Addendum To the I-81 Redevelopment Proposal: “Two Boulevards and a Bridge”

Carlo Moneti

August 24, 2015

Clarification of Liverpool/Destiny Exit proposal

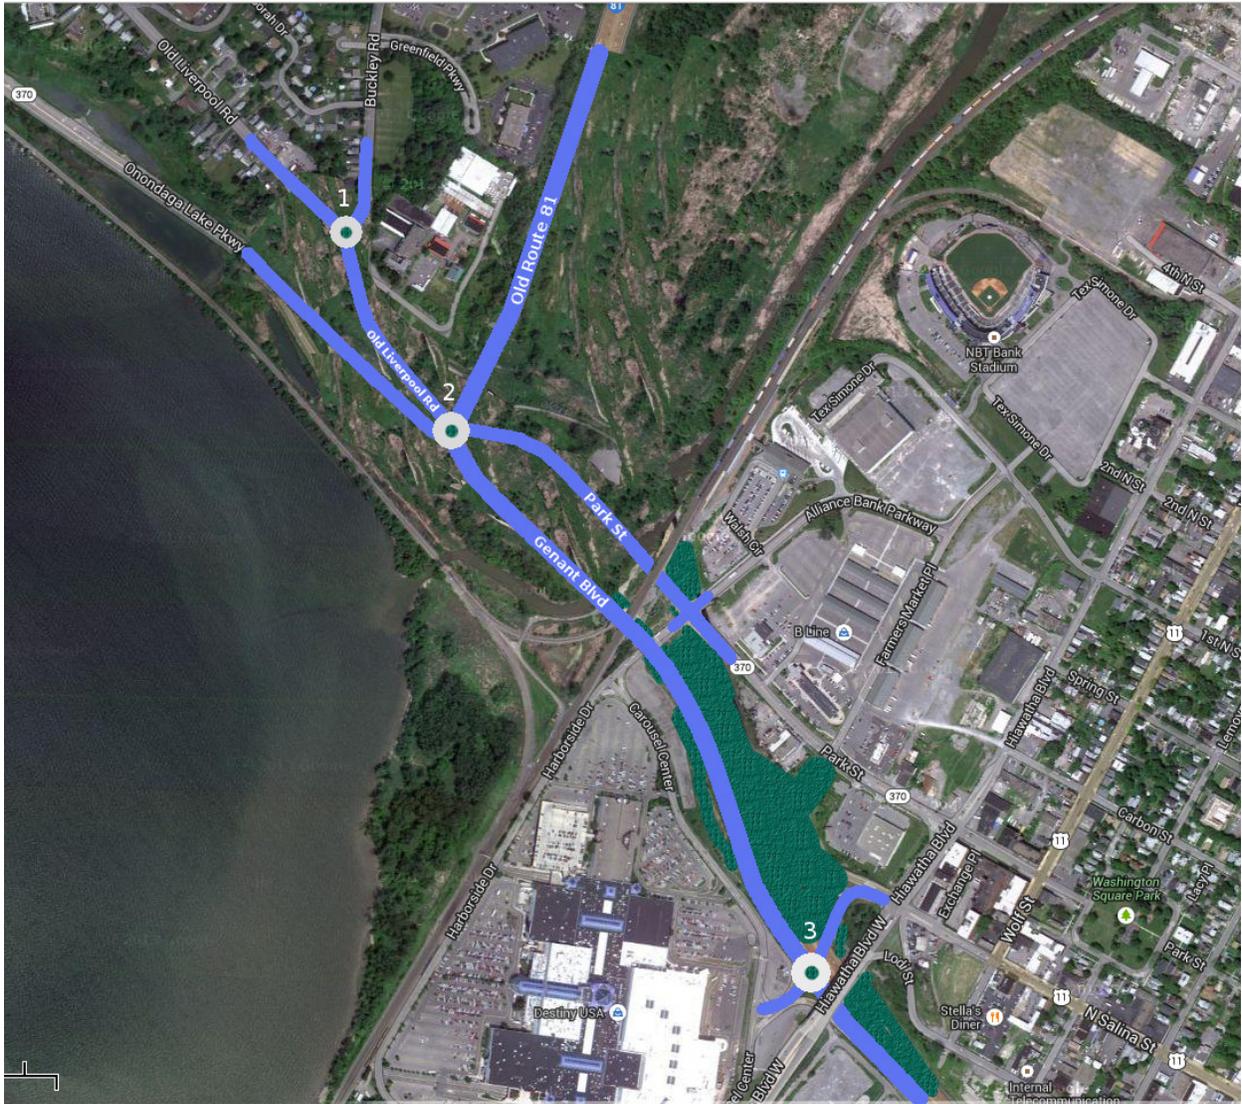
DOT concluded that the suggested changes reduced the number of effective road lanes from the current 5 to only 2, which is deemed insufficient for the projected traffic. In fact, the idea as envisioned would provide 4 lanes each way, not 2. The original description and graphic failed to state this explicitly. I apologize. As intended, Park St would be upgraded to 4 lanes (2 each way), and Onondaga Lake pkwy cum Genant Blvd would also have 4 lanes (2 each way). So, the change in lanes is from 5 to 4.

Figure 1: **Original Proposal:** As intended, Park St would be enlarged to 2 lanes each direction; Onondaga Pkwy cum Genant Blvd would have 2 lanes each direction; old route 81 would narrow to 2 lanes each way. Therefore, there are a minimum of 4 lanes southbound and northbound lanes, as opposed to 5 today. This concept may benefit from implementing two roundabouts as shown in Figure 2 (to be determined).

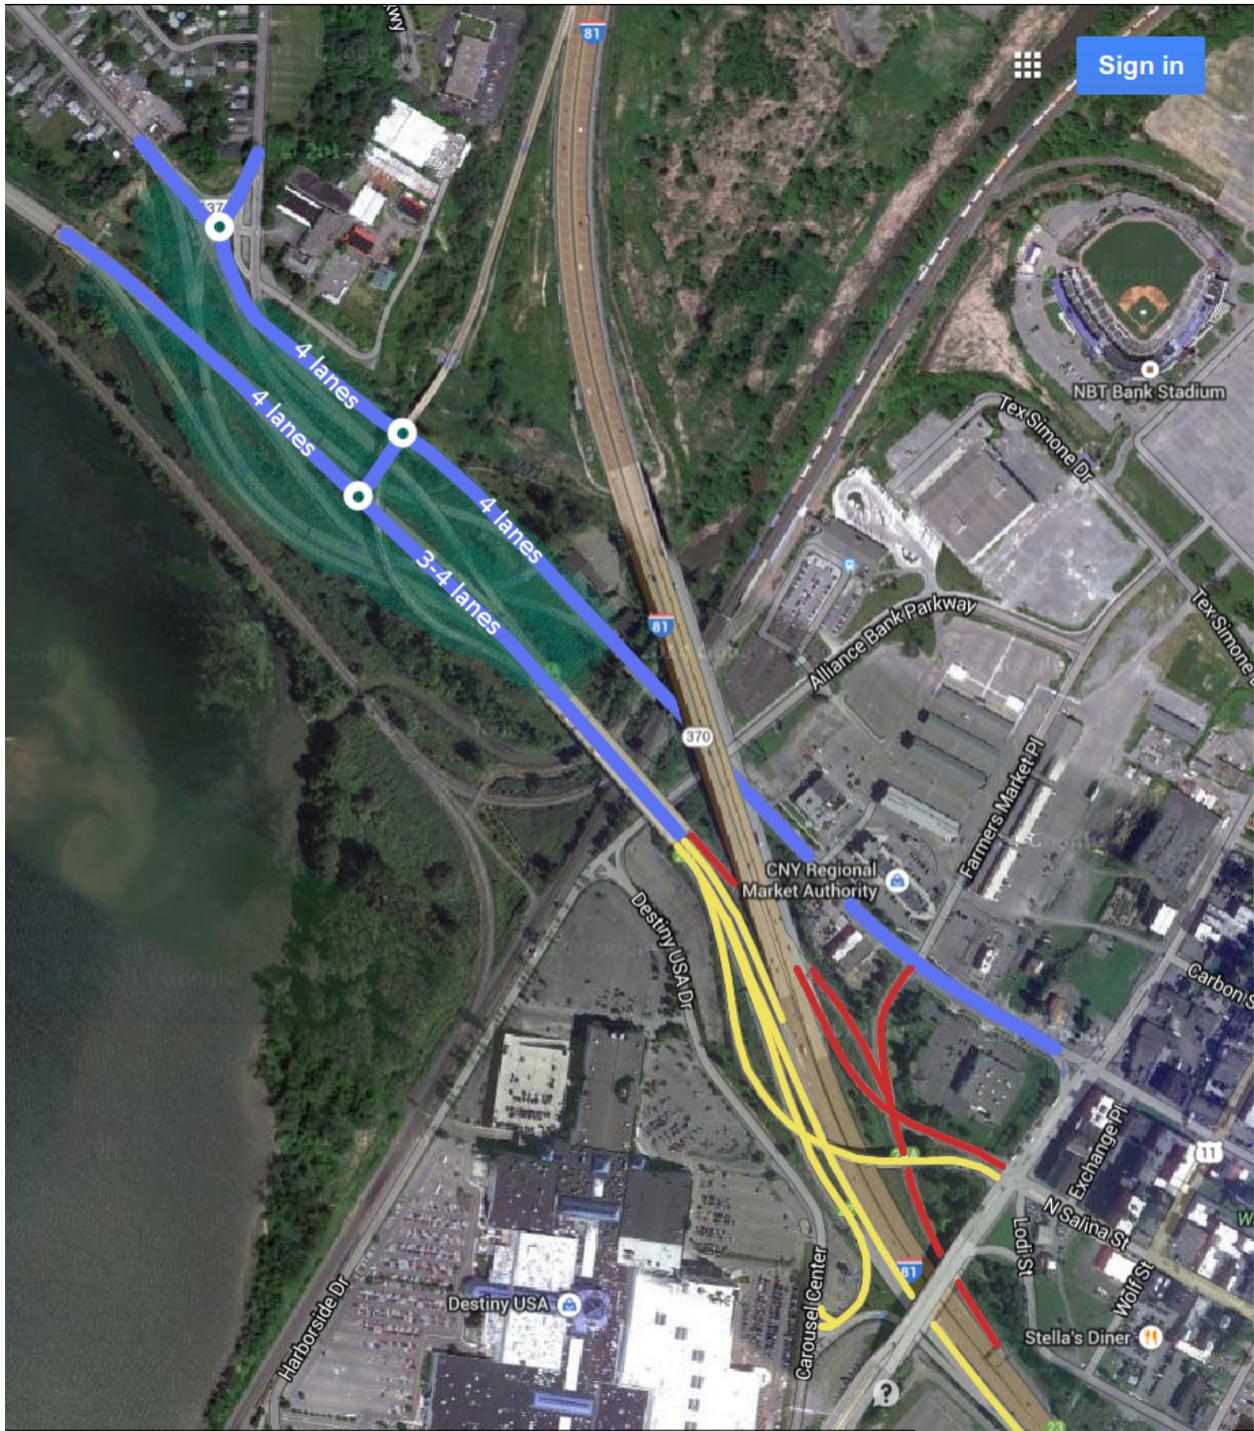
Figure 2: **Minimal Change:** I-81 and its connections remain unmodified, but the spaghetti junction at Liverpool Exit is eliminated by using roundabouts. Also, existing traffic lights and Stop signs are eliminated. The existing (unchanged) lanes, southbound (yellow) and northbound (red) are shown for clarity. This version shows 2 roundabouts where there was 1 in the original proposal; an alternative that may possibly add to efficiency and/or improve the future development potential of the area (to be determined).
